Subject: Recommended Changes to Zoning Ordinance

Re: Proposed Zoning and Development Code, June 2003 draft

Re: Comments on Preliminary Draft Dated June, 2003
Tempe Zoning and Development Code Re-write

TO: Fred Brittingham
FROM: David K. Jones
DATE: December 4, 2003
RE: Sign code

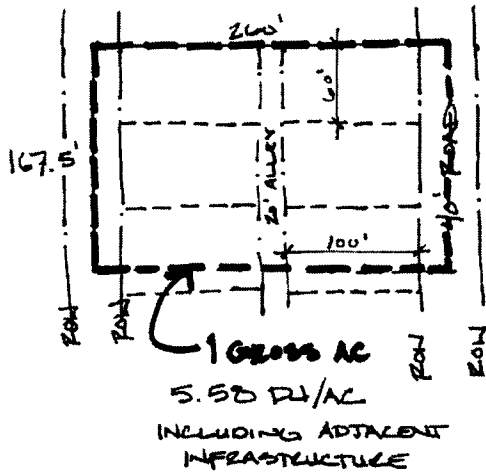
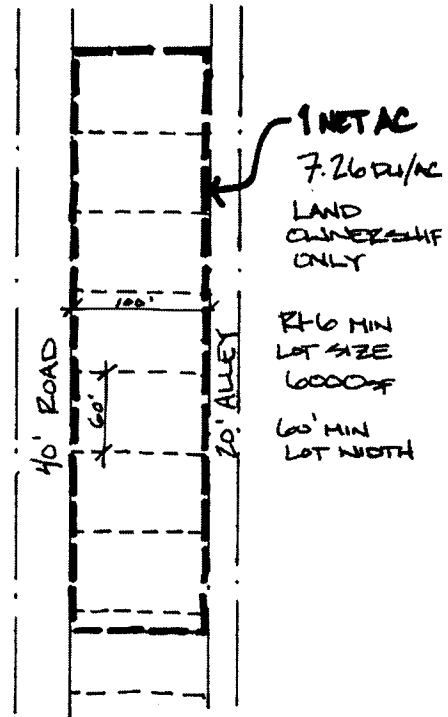
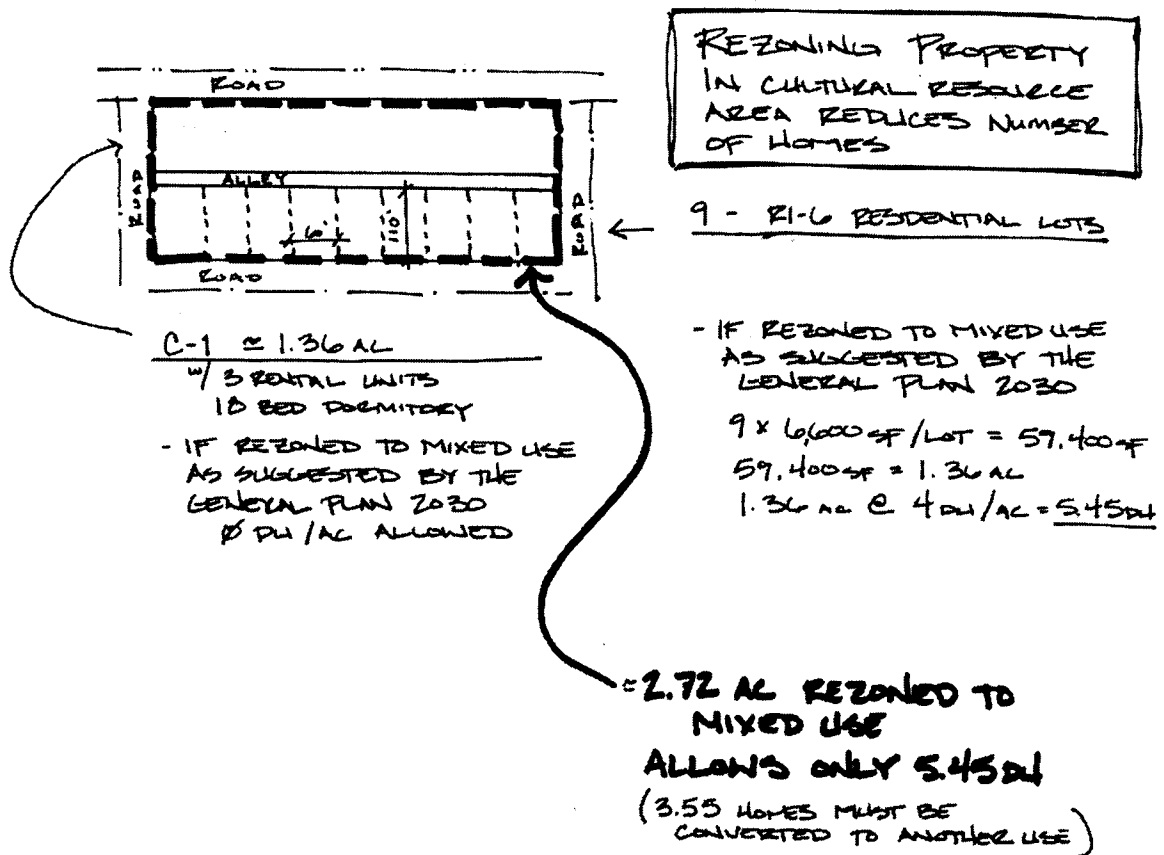
There are several technical issues we would like to call your attention to. The first arises with the density calculation, when already developed property is rezoned. When the area initially developed, the density of the site, for zoning purposes, was based on the gross site area, and included areas that would eventually become dedicated roads, alleys, parks, schools, and other public facilities and areas. In doing so, the developer was allowed to sell residential lots, as long as they met the minimum lot size requirement. In our area, that allowed for 6000sf lots since we have R1-6 zoning. When this same property is now rezoned, after development, the existing roads, alleys, parks and schools no longer sit on land owned by the applicant. Because of this, only the land actually owned is considered for the density calculations. The owner of a 6000sf R1-6 zoned lot with one home on it currently owns property the city would say currently has a density of 7.26 du/ac. $[43560 \text{ (number of sf in an acre)} / 6000 \text{ sf (the number of sf per house)}]$ Any rezoning of the property may not allow the property owner to continue to keep the same number of units currently existing.

We should be clear about existing densities, and the densities that truly result from each of our zoning categories. Doing so will make rezoning less cumbersome. When our block gets rezoned in the future to Mixed Use as suggested by the General Plan, if we wanted to keep the same homes on the site, we would apply for MU-1 which allows for 10du per acre. The neighbors may easily get up in arms as we are going from R1-6 which suggests it is limited to 4du/ac to an MU district at 10du/ac, when in actuality the entire R1-6 neighborhood is already above 7du/ac.

To resolve this issue, we recommend adding a column to the zoning chart (table 4-202A) that allows density in already developed areas, at time of rezoning, to be based on the zonings' minimum lot size. This recommendation will not increase the allowed density in these areas; it will only allow the density to be calculated properly for already developed areas. This would bring the existing conditions of the neighborhoods in line with how the Planning and Zoning Staff calculate density at the time of re-zoning.
